Addition to Bethesda-Chevy Chase High School, Bethesda CBD, Mandatory Referral, MR2016014

Date of Report: 1/29/16

- Mandatory Referral for the proposed addition of Bethesda- Chevy Chase High School, Bethesda Central Business District.
- Located at 4301 East-West Highway, approximately 1,200 feet east of Wisconsin Avenue
- R-60, 1994 Bethesda Sector Plan
- 16.36 acres
- Applicant: Montgomery County Public Schools
- Filing date: 12/11/15

Pedestrian and vehicular circulation plan

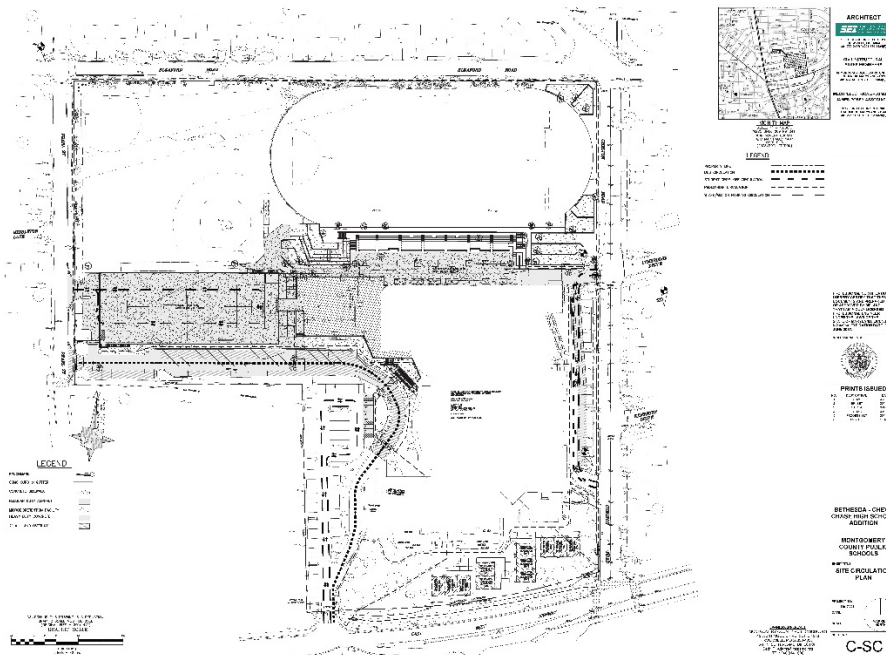
In order to accommodate the increased enrollment, the application proposes a new parking garage on the site of the current school parking lot adjacent to Pearl Street. Internal site access and circulation around this garage will remain similar to the current operations. As a result of the proposed project, the school will have a total of 295 standard parking spaces, an increase of 62 spaces over the currently available 233 spaces.

The pedestrian network within and around the site is generally complete and provides adequate accommodation for large volumes of pedestrians travelling to and from the site. Sidewalks vary between 5-6 feet in width.
